Below you will find my comments on the HFT proposal draft. We've already seen remarks from Spiros. Hopefully, the other committee members will send their comments quite soon now. Meanwhile, the HFT team is supposed to be sending us preliminary cost and schedule information any day now.

I've finally made it through the entire HFT proposal draft. There's a lot of good stuff here. If we get a favorable review panel, it could fly through. But I'm more concerned than Spiros was that the present version is open for trouble if we get a review panel that is "out to get us". Why?

Figure 1: The predicted pointing resolution of the TPC+SSD+SVT at the vertex in the R-Phi direction. The blue line shows the pointing resolution for all three SVT layers. The red line shows the effective resolution if the first layer of the detector is not hit and only layers 2 and 3 have hits.

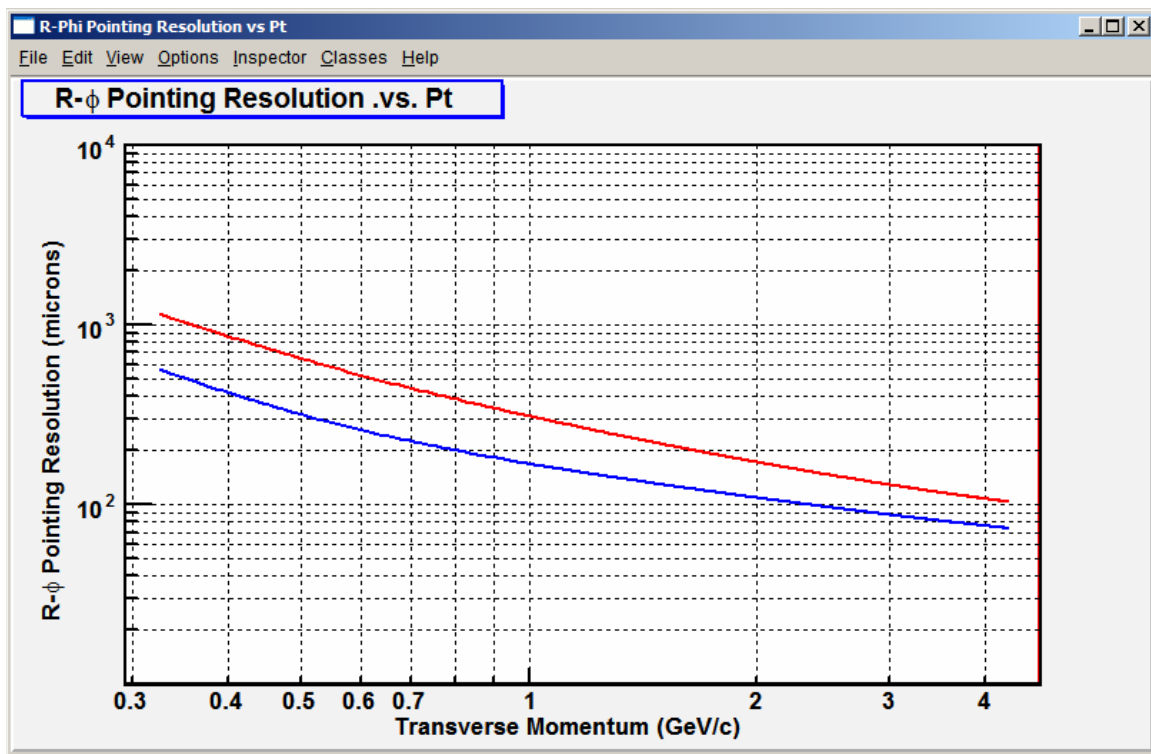
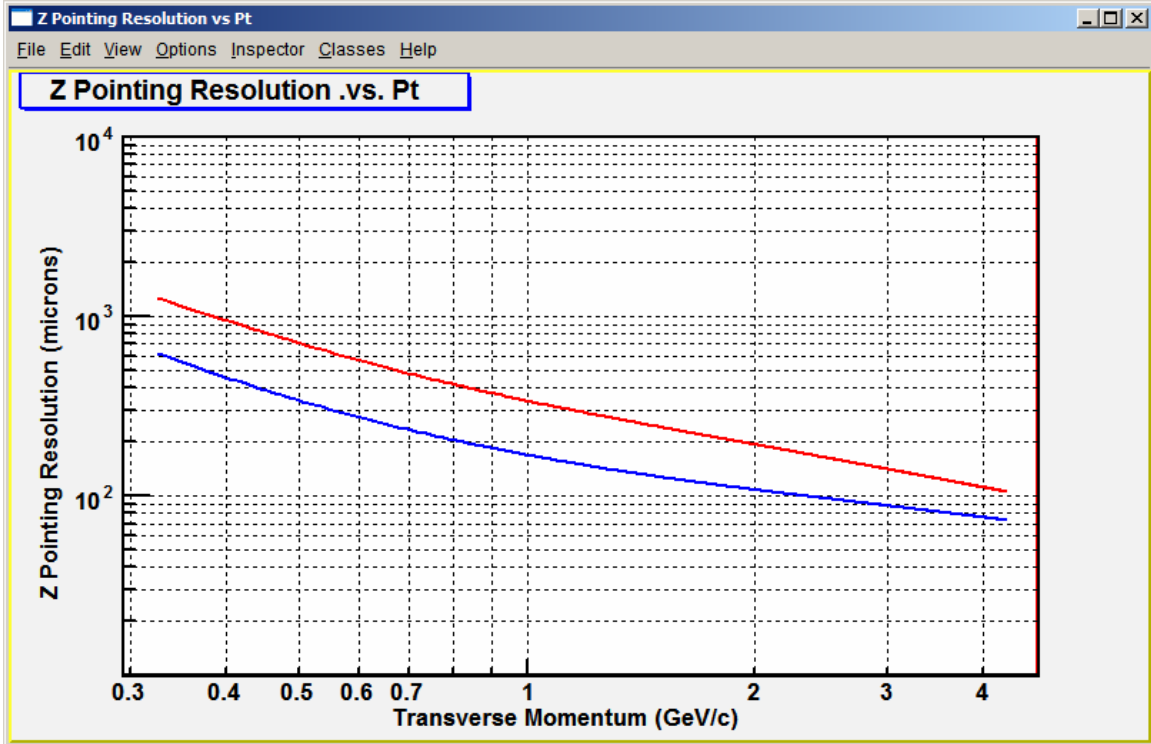
-- Multiple scattering. The current draft does a very nice job of showing how the HFT performance can be predicted/understood with simple "hand calculations". Why don't you include a similar hand calculation for the existing system? That should demonstrate its intrinsic limitations for topological charm reconstruction very clearly.

The predicted performance of the SVT detector system is shown in Figure 1 and Figure 2. The system is MCS limited so even though the detector resolution on each SVT layer is assumed to be 50 μm in the R-Phi direction and 40 μm in the Z direction, the pointing resolution at the vertex is not as good.

At the mean p_T of the Kaon from the decay of a D^0 (750 MeV), the pointing resolution is about 200 μm in the R-Phi and Z directions. This gives us the possibility of seeing D^0 s with the SVT ... but the software reconstruction efficiency is not expected to be very high due to the relatively poor pointing resolution that is supposed to pick out a non-vertex decay with $c\tau \approx 125$ microns.

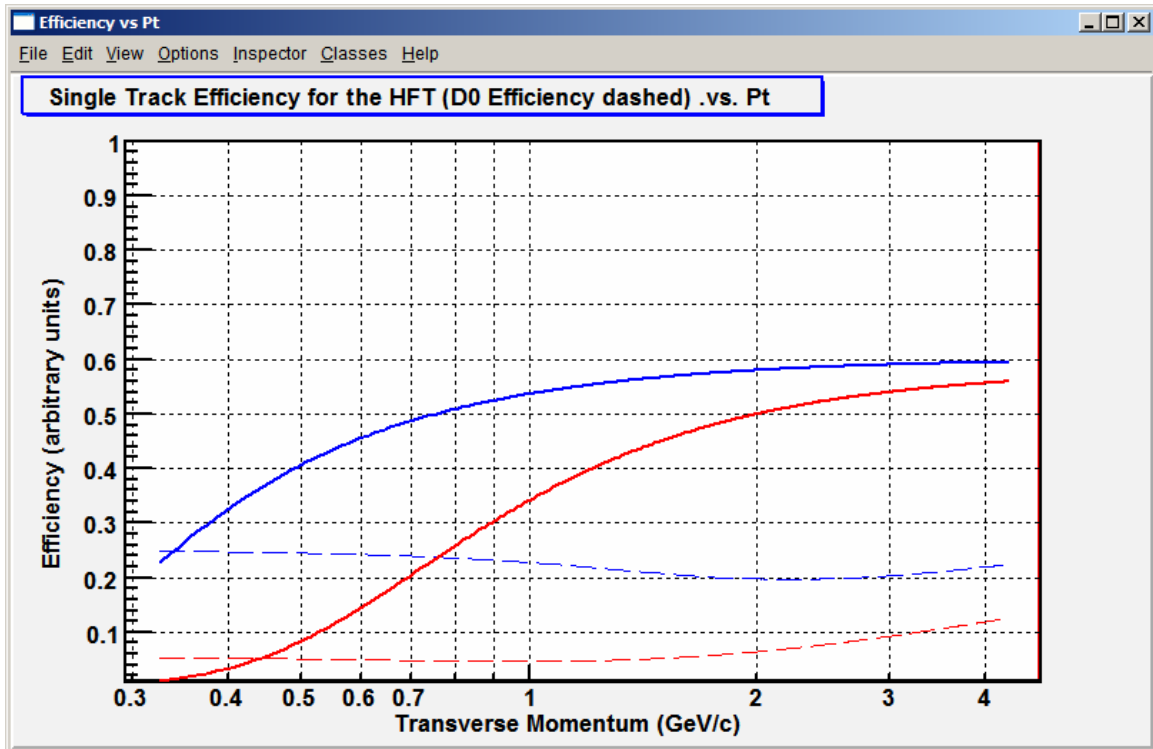
I also have a closely related concern that is not discussed at all in the current draft. As I understand it, the integration time for the prototype detector will be 4 ms vs. 200 us for the final detector, i.e. a factor of 20 longer. During Run 7, we were often up and taking physics data when the instantaneous luminosity was around 30% of the expected typical RHIC-II luminosity. If I put those two numbers together, I conclude that pile-up in the prototype at RHIC-I luminosities is going to be up to 7 times worse than in the final detector at RHIC-II luminosities. How is the prototype going to perform under such extreme conditions?

The 4 msec detector is a good detector because it allows us to learn about the technology, and learn how to build a high tolerance detector alignment system; and thus ensures success with the final detector. But a 4 msec detector is not the best detector for doing D^0 physics. It is relatively slow and thus suffers for a large amount of pileup. For example, Figure 3 shows the predicted efficiency for a 4 msec detector compared to a 200 microsecond detector based on hand calculations. The solid blue line is the single track efficiency for finding a kaon in the TPC+SSD+IST+PXL. The dashed blue line is the efficiency for finding D^0 's and is a translation of the single track efficiency curve after doing the Lorentz kinematics representing a pair of daughter particles from the decay of the D^0 parent.

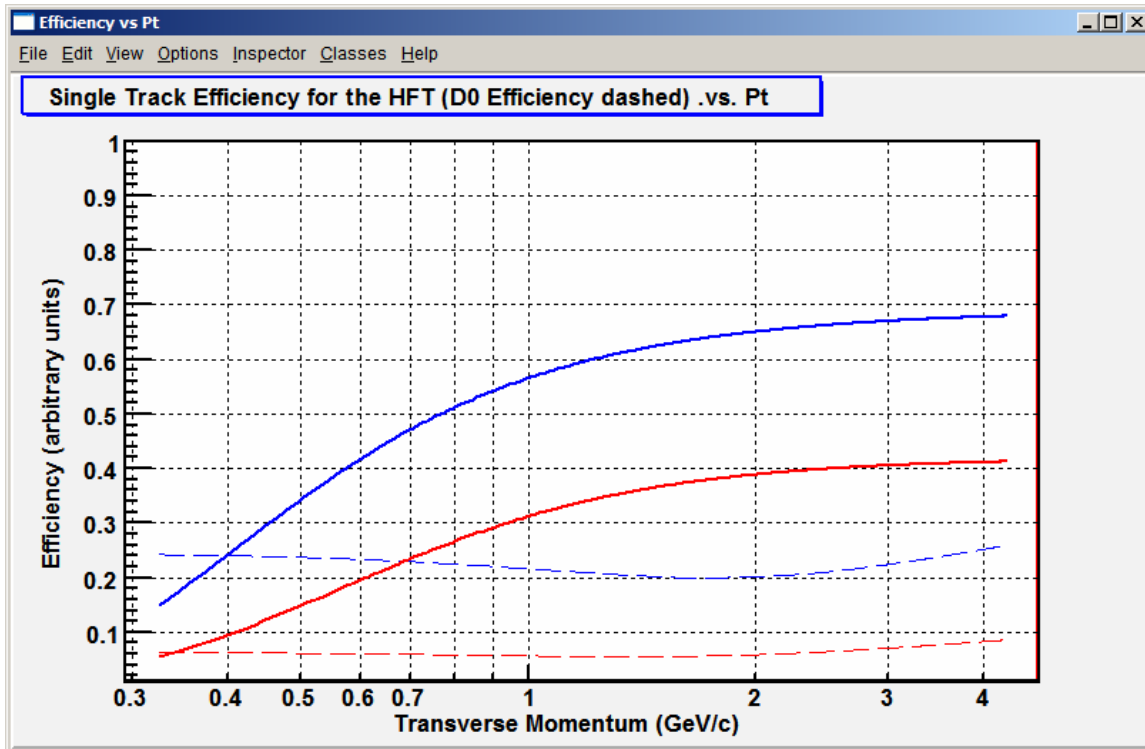
Finally, my last general remark is that the current draft never really tries to justify the need for the IST layers. However, unlike the above issues, that's probably okay for this stage. But their importance will need to be made clear at the CD-1 and CD-2 stages. (Maybe through explicit simulations showing what happens as various layer(s) are removed?)

The IST is not needed to do heavy ion physics with a 200 μ sec detector. The IST is a spin detector and should be evaluated on its merits to enhance the spin program. Figure 4 shows the predicted efficiency of the HFT without the IST layers. The TPC+SSD+PXL detectors are all active. The IST layers are not used. Further, the calculations in Figure 4 are deliberately pessimistic to show that the system still works when extra background is added and the detector resolution is twice as bad as assumed by the detector design specifications. The primary conclusion is that the system (minus IST layers) works.

Another important conclusion can be drawn from Figure 4: the SSD is required to do good physics with the HFT. The red line in the figure shows what happens when the SSD is removed from the tracking system; the D0 efficiency drops by a factor of 4.

The reason that the HFT works without the IST layers is because the pointing resolution of the TPC+SSD is sufficient to guarantee that the PXL layers are highly efficient even in the presence of pileup. The pointing resolution of the TPC+SSD system, under pessimistic assumptions, is good enough to keep a 200 μ sec detector from being overwhelmed at RHIC II luminosities. In fact, the inefficiency of the first pixel layer is only 4% (see Equation 1) and so it is difficult to make a dramatic improvement upon this level of inefficiency. The second pixel layer is less efficient but the addition of the IST layers do not help that problem because they have a relatively short lever arm compared to the SSD and their long strips introduce ambiguous hits that increase the apparent hit density so that the IST hurts a 200 μ sec detector as much as it helps. This conclusion is not true for a 4 millisecond detector. A 4 millisecond detector must have the IST layers as well as the SSD in order to handle the extraordinary levels of pileup.
